Hornsby Ku-Ring-Gai Hospital Stage 2 – State Significant Development Project (SSD 8647)

Response to Submissions Report 2
NSW Health Infrastructure
12 April 2018

Response to Submissions Report – SSD 8647 – HKH Stage 2 Redevelopment

Figure 3 – Recommended Screen Around Existing Generator

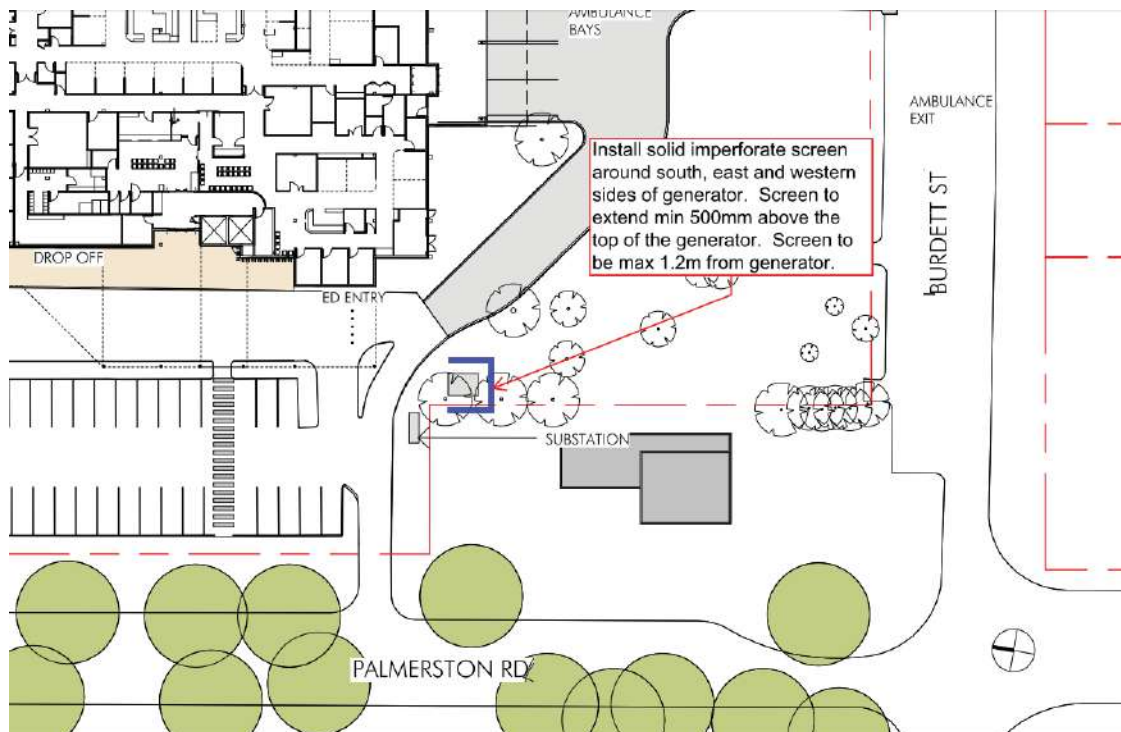
- Install a solid, imperforate (i.e. no holes) screen around the south, east and western sides of the generator as shown in Figure 3 below.
- The screen is to extend a minimum 500mm above the top of the generator and is to be located no more than 1.2 metres from the generator.
- Suitable materials for the screen include 6mm fibre cement, lapped and capped timber or Colorbond metal.

Page L01 E

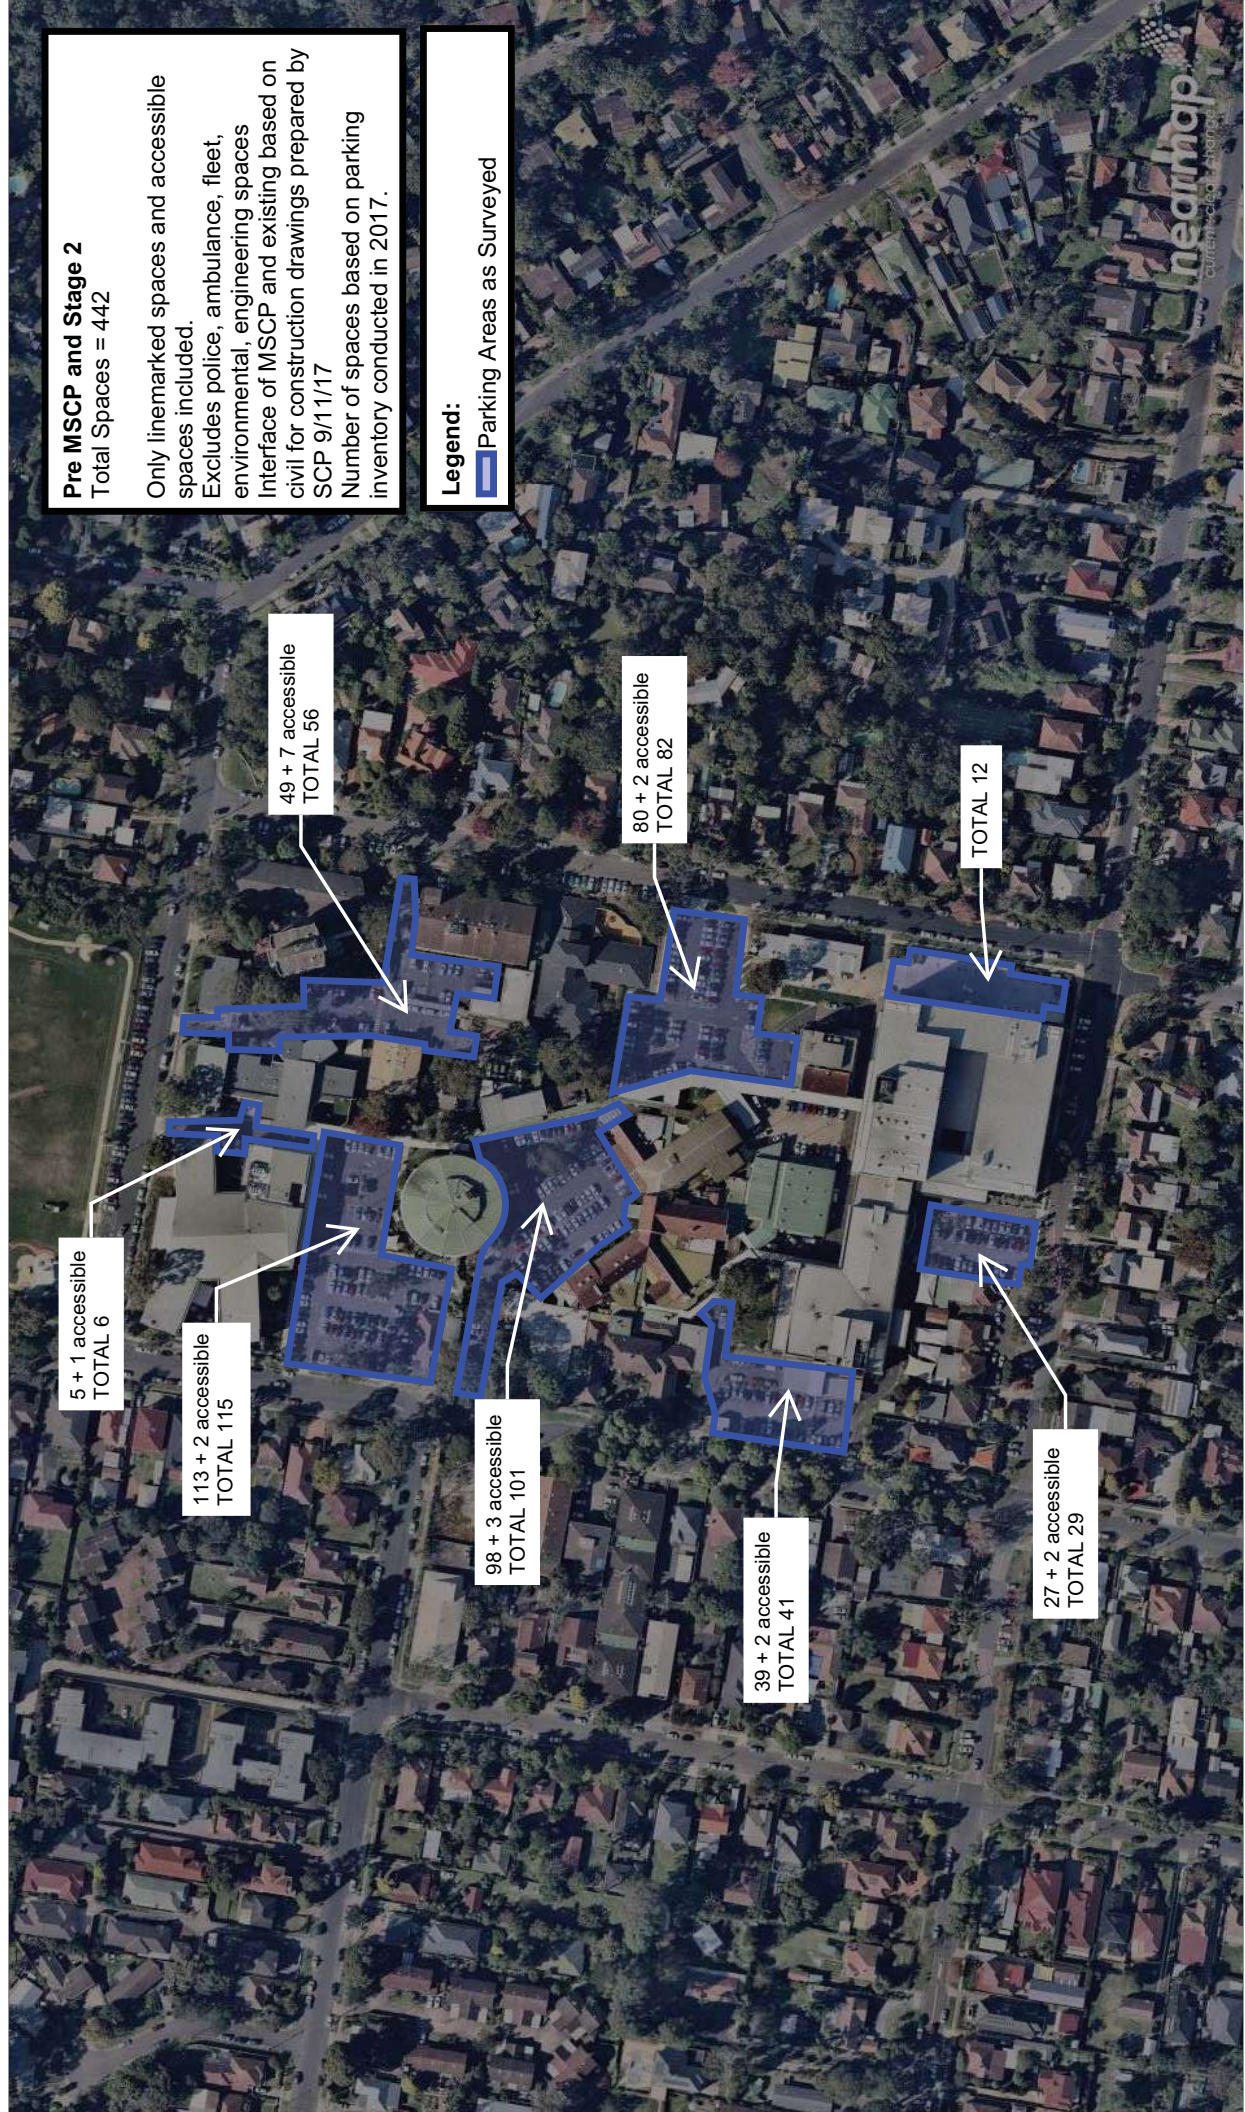
2.0	Government Architect NSW			
		Master Plan verse Landscaping Plan		
2.1	Government Architect NSW	We have reviewed the relevant sections of the RtS submitted by Health Infrastructure on February 26, 2018. The proponent responded to our letter dated December 15, 2017 with additional information. We note that the master plan supplied in RtS Appendix C is different to the landscape plan. We assume the landscape plan to be correct.	We confirm that the landscape plan is correct – we note for clarity that the demolition of the Lumby Building does not form part of this application, refer to Appendix B.	Appendix B – L01E Landscape Masterplan
		Request for Public Domain Strategy

3.4	Department of Planning and Environment	The 'Landscape Masterplan' (drawing no. L01 E) is inconsistent with the detailed Area 2 Landscape Plan (drawing no. L03 D). Please correct.	Please refer to Appendix D – updated Landscape Plan L03 E.	Appendix D – L03E Area 2 Landscape Plan
		Gross Floor Area (GFA)		Appendix E – GFA Calculation

Appendix G. Separate Approval Mark-up

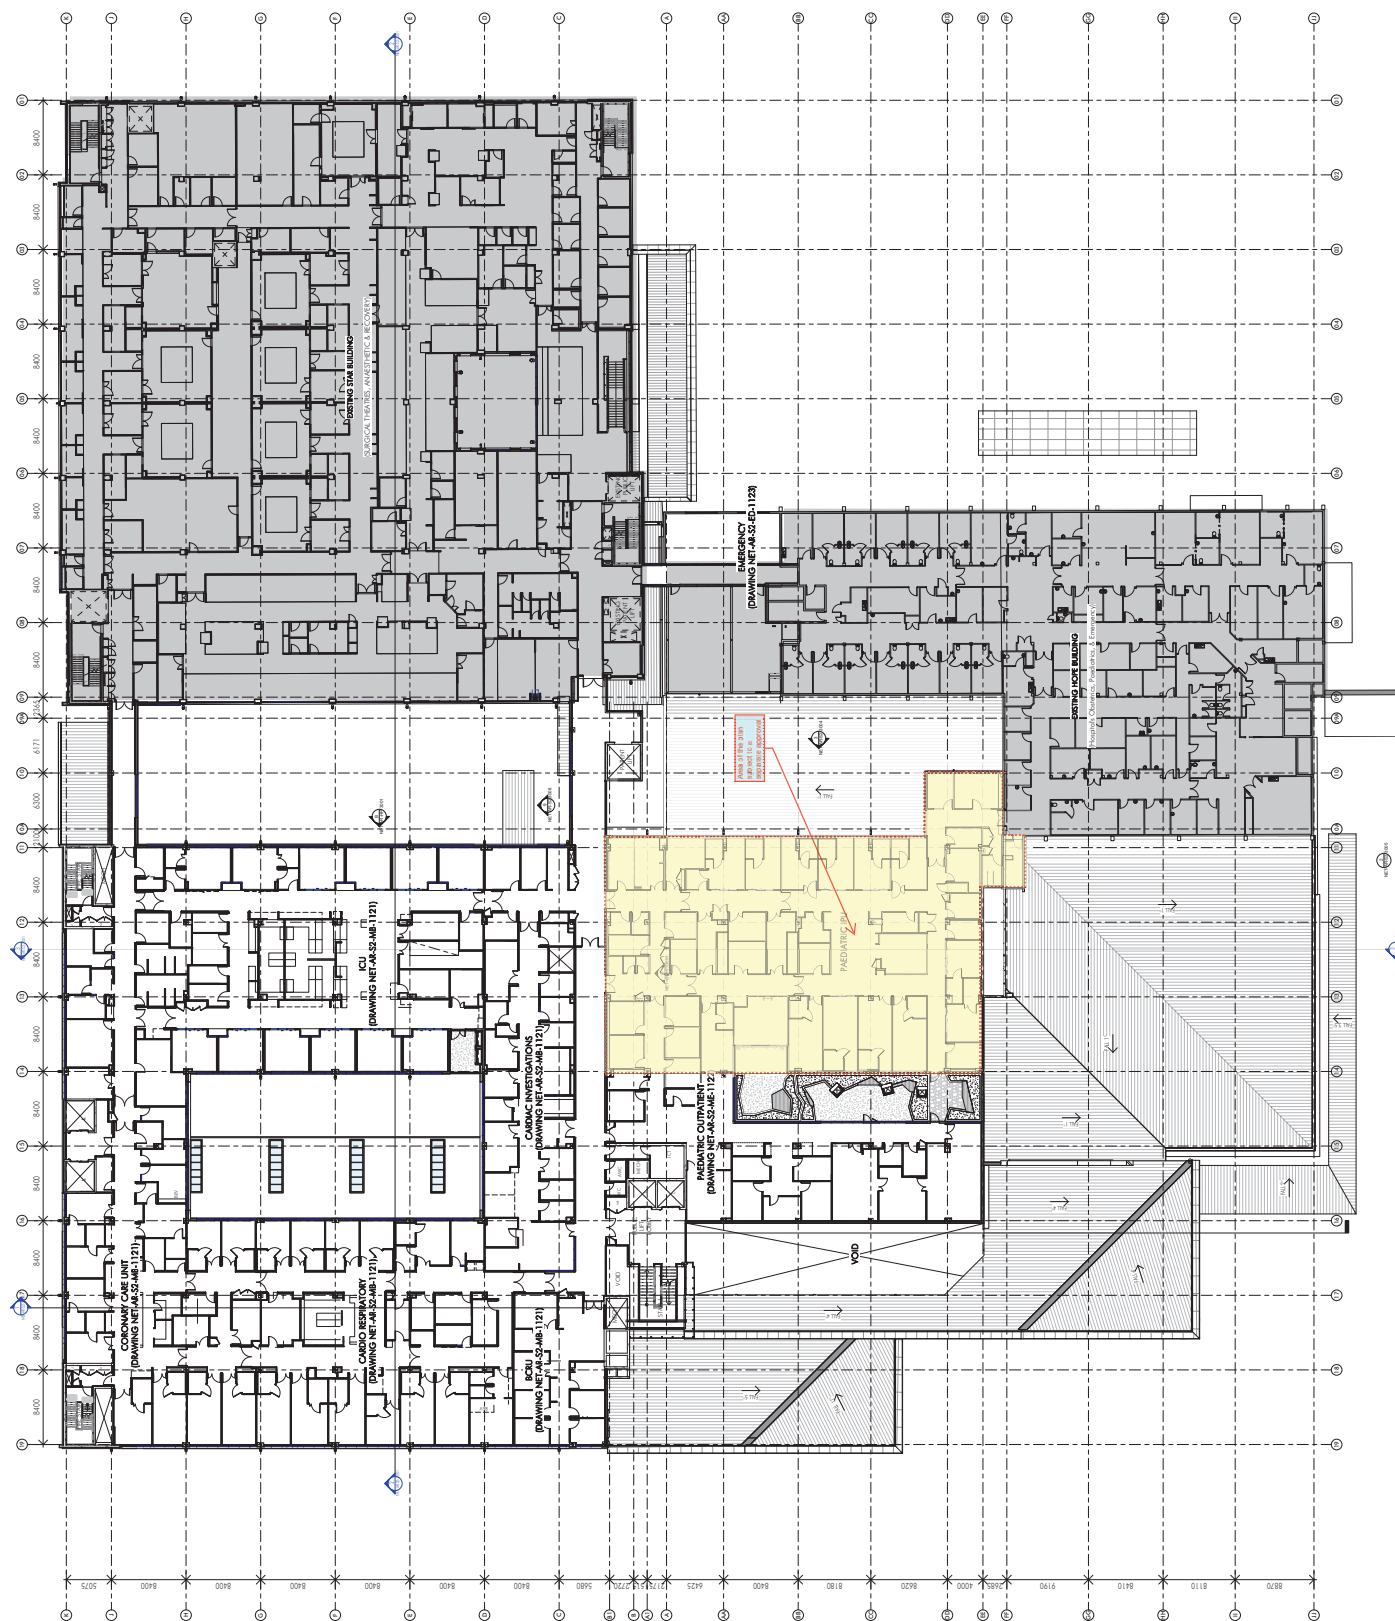
3.8	Department of Planning and Environment	The 'Level 2 – Overall Plan' (drawing no. NET-AR-S2-1021 Rev 4) includes the 'paediatric IPU' and 'paediatric outpatient unit' which is partially located above the approved medical imaging building. It is understood from the EIS that the paediatric unit was approved under Part 5 along with the medical imaging building. Please clearly indicate on plan which elements of the paediatric unit are subject of this application.	Please refer to Appendix 7 showing mark up of area subject to the separate approval.	Appendix G – Separate Approval Mark-up
		Architectural Plans
